<b>SB Number:</b>	<b>SB 2BX-003</b>	<b>Creation Date:</b> 06/04/2004
<b>Subject:</b>	Improve paper transport (change SPRING ACTUATOR REG')	
<b>Model:</b>	FS-1010, FS-1050

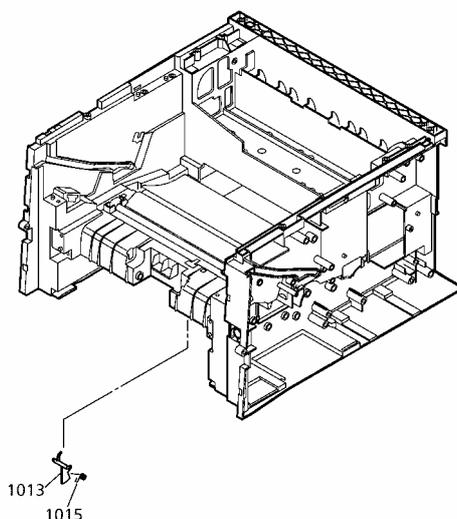
In order to improve the reliability of paper transport in the FS-1010/1050, the 'SPRING ACTUATOR REG' has been changed as follows.

Spring load has been reduced.

No.	Part No. OLD	Part No. NEW	Description	Q'ty old-new		Interchange ability	
1	5MMW151LD005	5MMW261LD057	SPRING ACTUATOR REG	1	1	O	O
